**RE: Response to comments on the 3 October 2023 technical memorandum titled “Modelling of drawdown impacts from proposed rig supply bores in the Bennett Resources Valhalla Gas Development Project”**

**Re:** Revised modelling of drawdown impacts from proposed rig supply bores in the Bennett Resources Valhalla Gas Development Project

Figure 5-1. Mod 1 model results presented as drawdown contours after 6 months of pumping with contour interval = 0.2 meter.

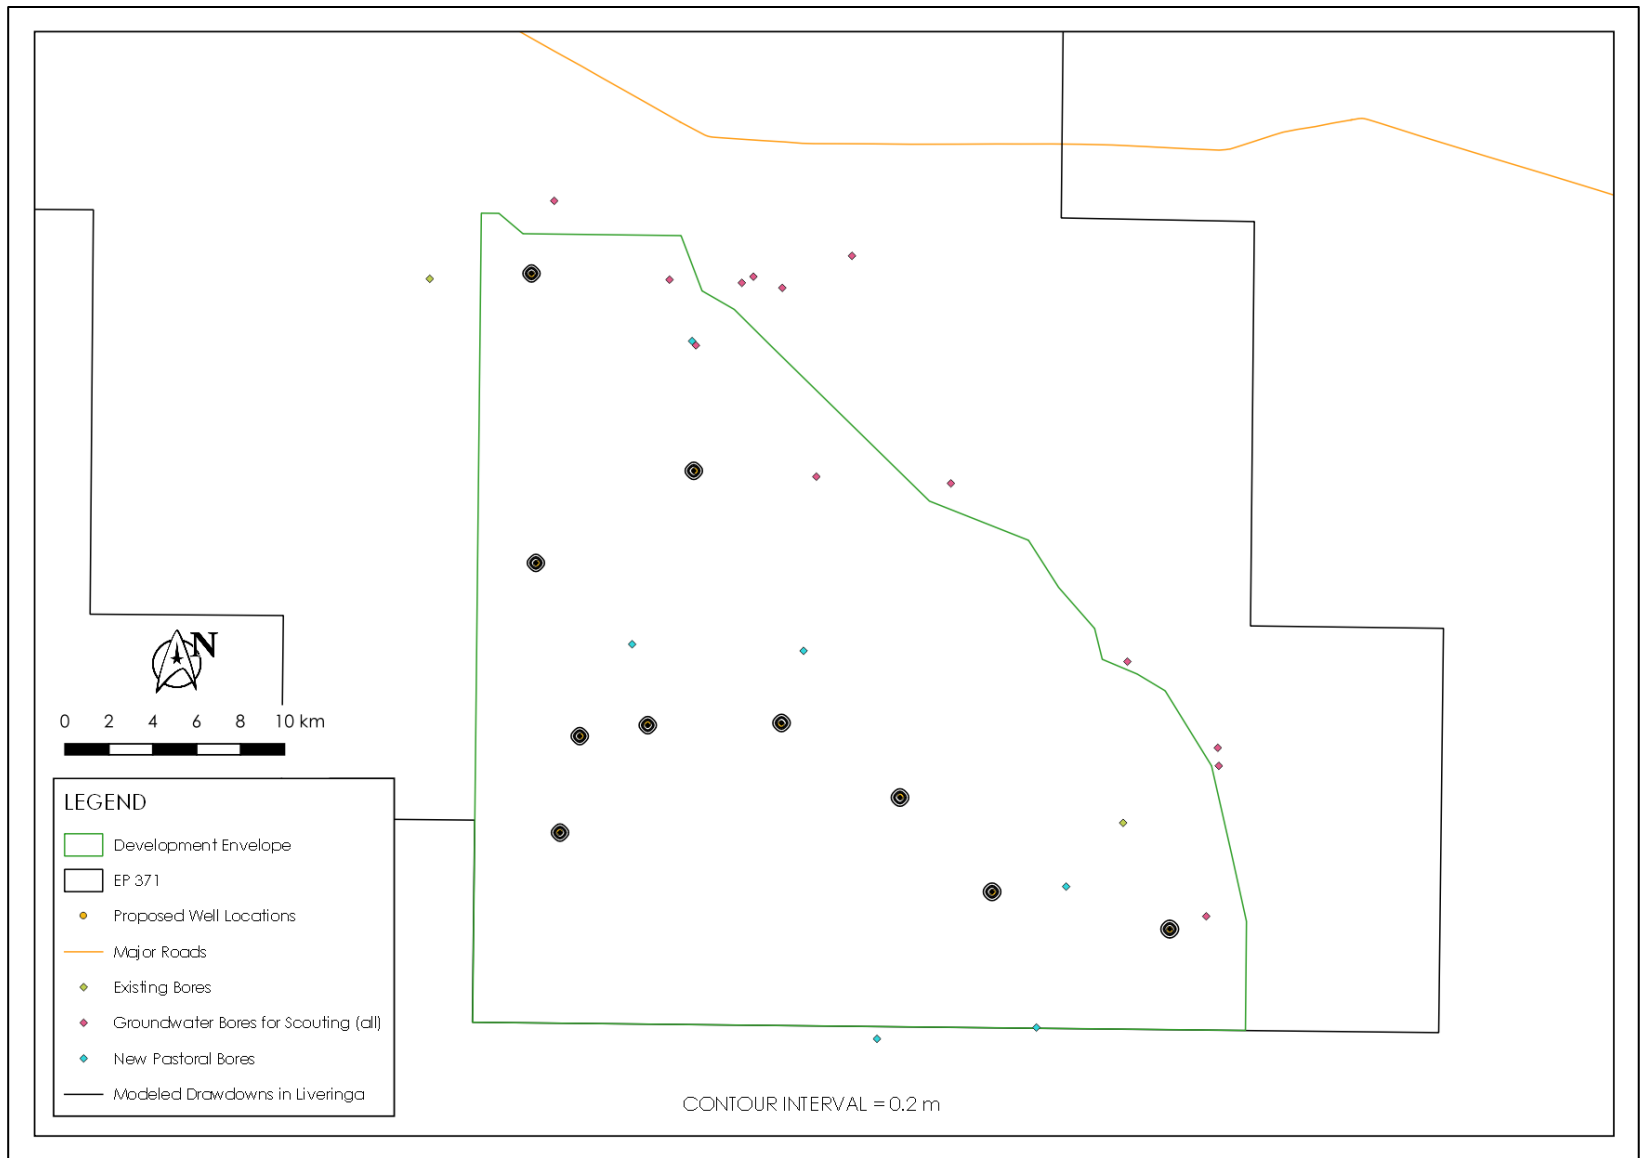
1. *The model has several parameter assumptions and many limitations.*
  - a. *Can the parameters and assumptions be clearly stated. Specifically, can a sensitivity analysis be conducted for these parameters [aquifer/aquitard thickness, hydraulic conductivity, aquifer thickness, storage] (i.e. increase/decrease the values and run multiple options through the model to understand the impact of these assumptions)*

- b. *Can a number of extraction rates be studied to understand impacts of varied extraction rates.*
  - c. *Can the limitations be described and justified why they are suitable for the purpose of this analysis.*

For all 36 simulations the modeled drawdowns at each existing bore (see Figure 5-1 for existing bore locations) were 0.01 m or less, which is considered to be less than the resolvable precision of the model and is interpreted to indicate no impact from pumping on existing bores. This suggests that, even with the most conservative conditions, pumping from the proposed bores completed in the unconfined system will not result in any observable impacts to existing bores.
